RFT 26-031 Milton # 13 Elementary School and Child Care Facility

PROJECT NO. 22124
HOSSACK & ASSOCIATES ARCHITECTS

ADDENDUM NO. 3

Issued February 24, 2026

5 ASPHALT DETAIL
 SP2 SCALE N.T.S

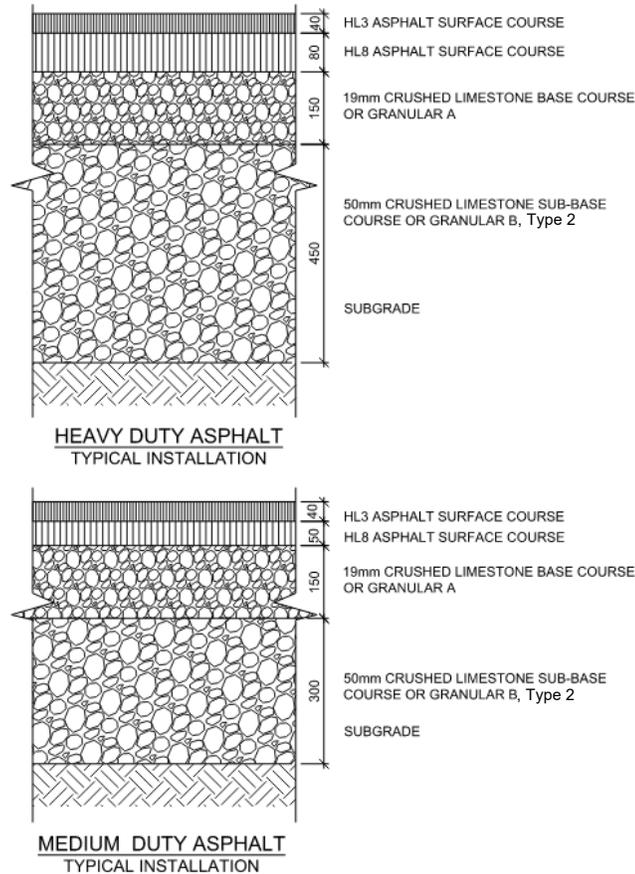
Item 07: SP2 Site Plan Details:

.1 REVISE detail drawing 5/SP2 'Asphalt Detail' as follows:

NOTE:
 REFER TO GEOTECHNICAL REPORT TO CONFIRM THAT ADDITIONAL DEPTH IS NOT REQUIRED AND THAT DEPTHS/MATERIALS OF ASPHALT AND SUBGRADE COMPONENTS MATCH THESE MINIMUM STANDARDS.

REFLECTED CEILING PLAN - GROUND FLOOR

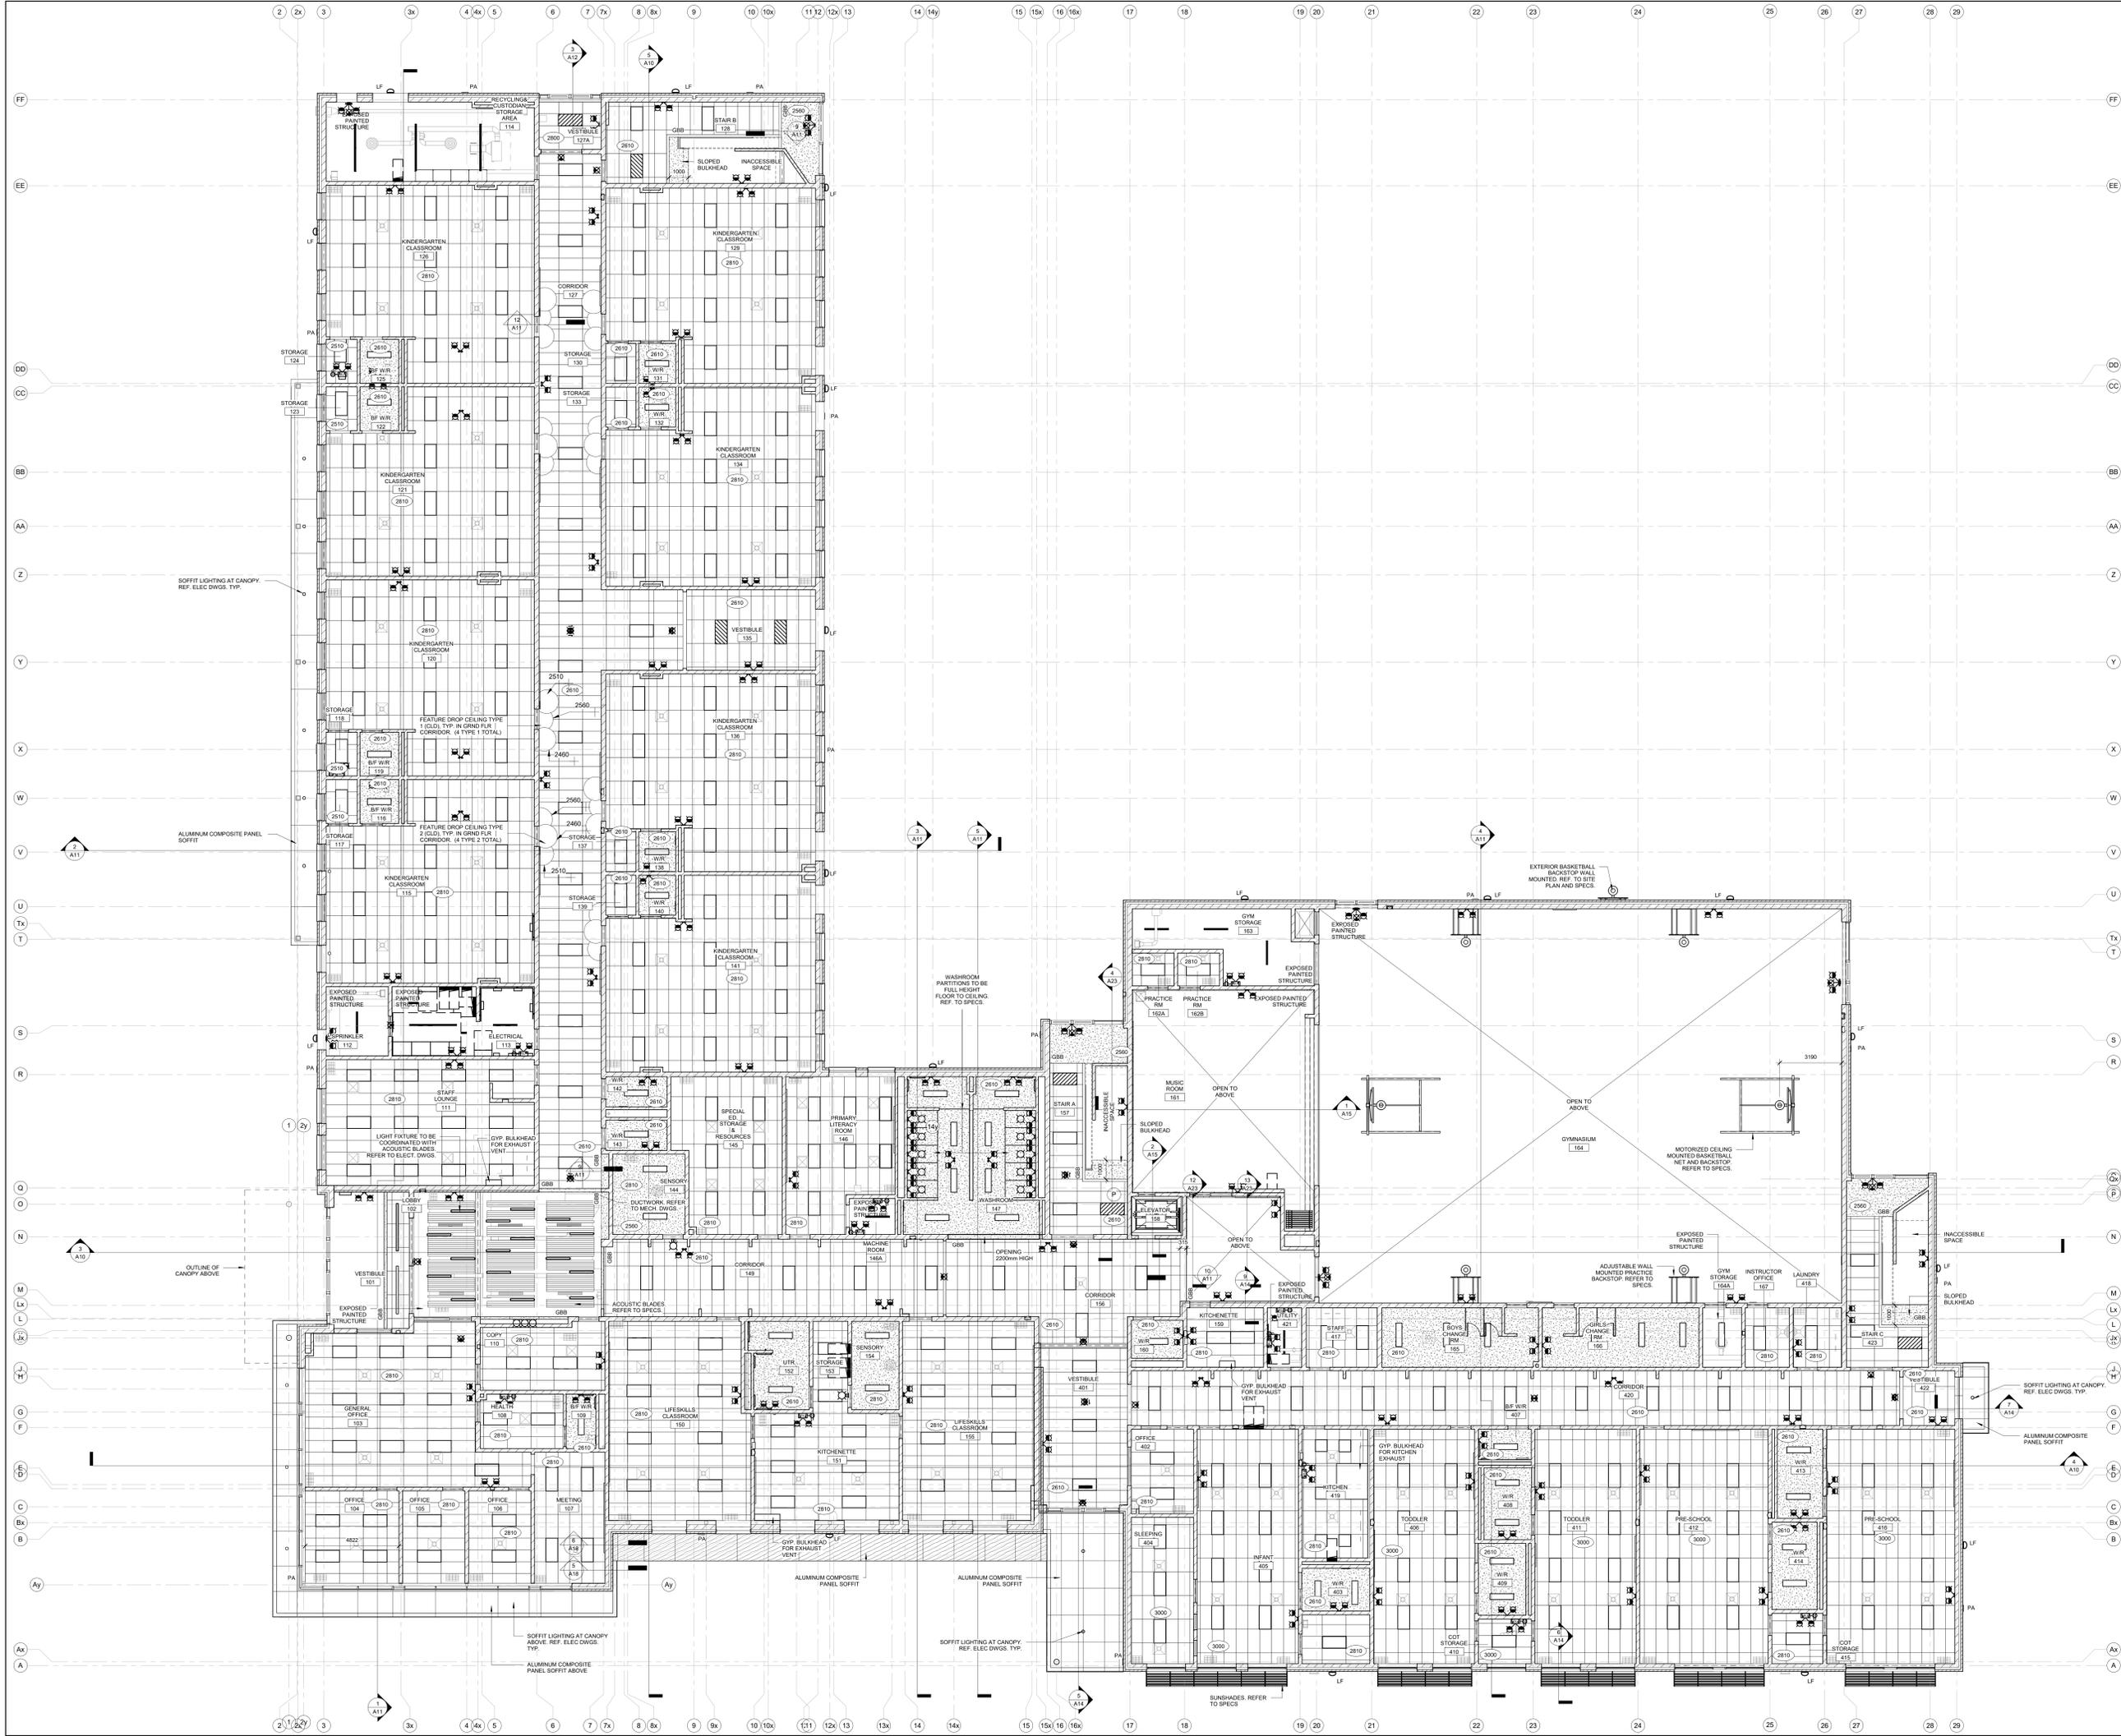
QUESTION 1: Drawing A06 Reflected Ceiling Plan - Ground Floor is missing from the drawing set in the bid package. Please provide.

Item 08: A06 Reflected Ceiling Plan – Ground Floor:

.1 ADD full size 36" x48" drawing, A06 Reflected Ceiling Plan – Ground Floor dated, February 5, 2026. Attached.

ANSWER 1: [Please refer to drawing 'A06 Reflected Ceiling Plan – Ground Floor' enclosed.](#)

Project Name:
MILTON #13 PUBLIC ELEMENTARY SCHOOL
MILTON ONTARIO
Sheet Description:
BULK ROUGH GRADING PLAN AGREEMENT SCHEDULE

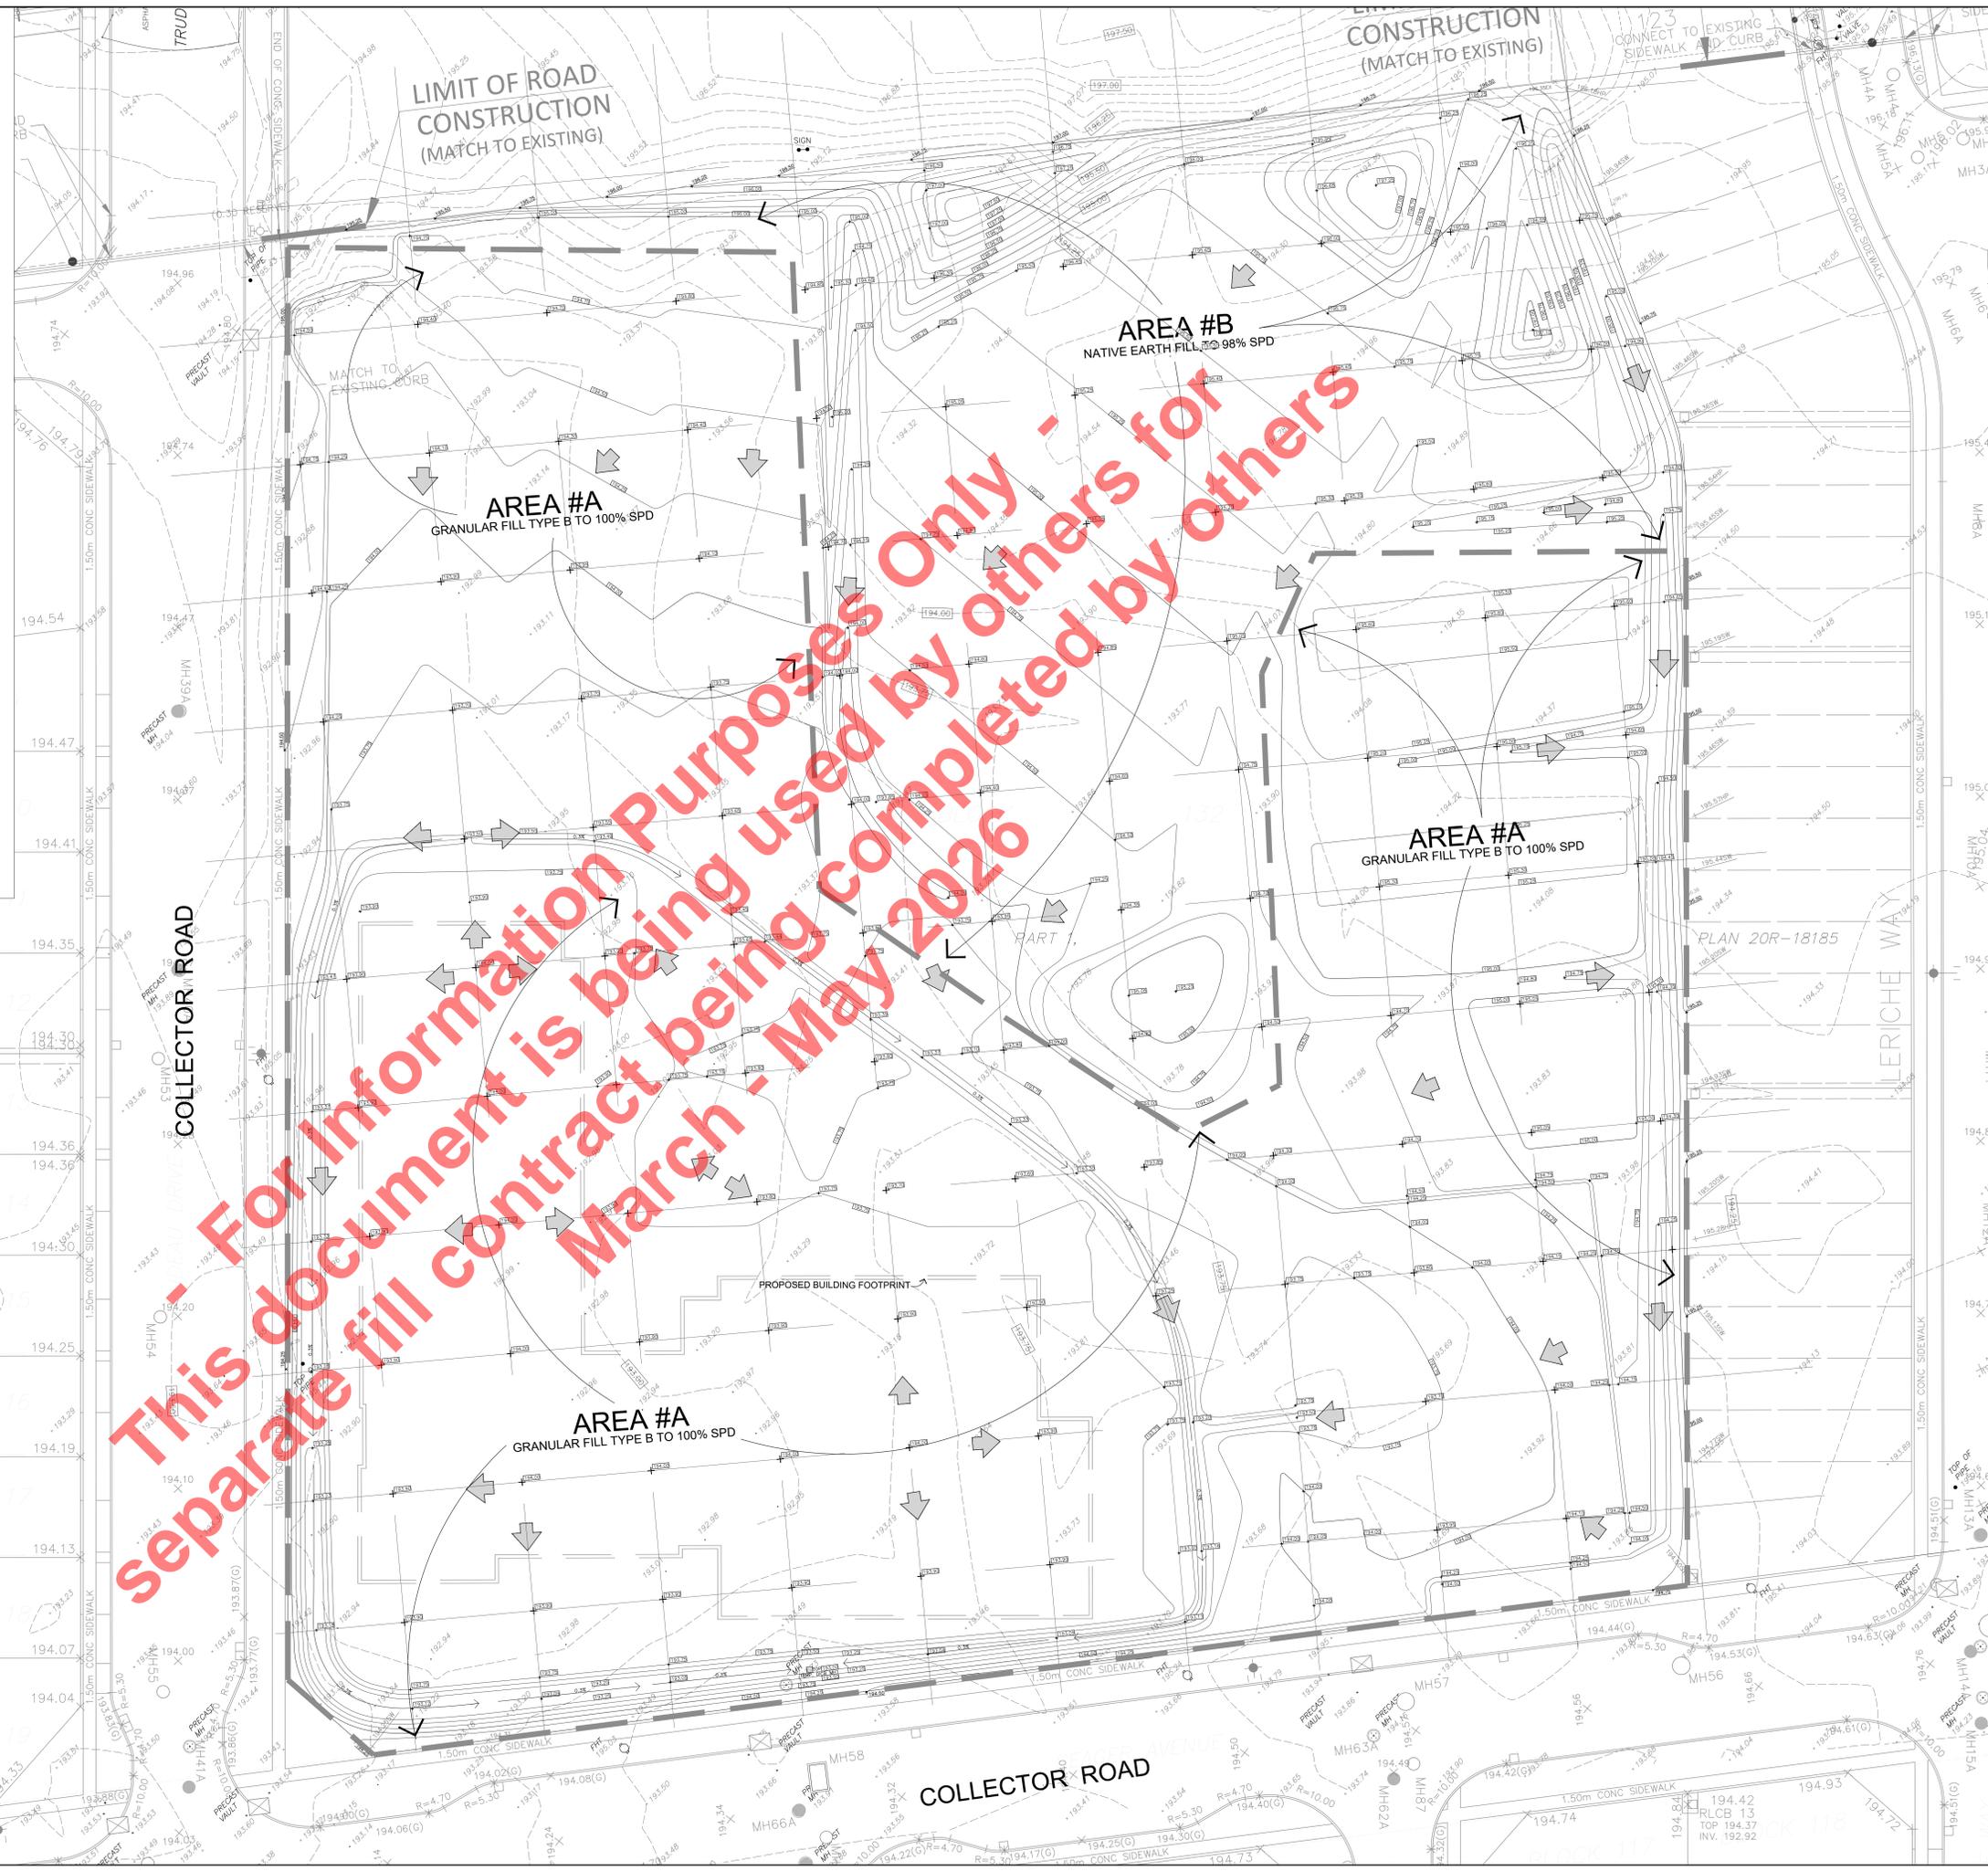
Item 06: BRG.1 Bulk Rough Grading Plan:

- .1 INFORMATION ONLY: BRG.1 Bulk Rough Grading Plan is being provided for information only as to the material being used to upfill the site, prior to this contract commencing. This site upfill is being carried out as a separate contract by others, to be completed prior to the work for this contract commencing.
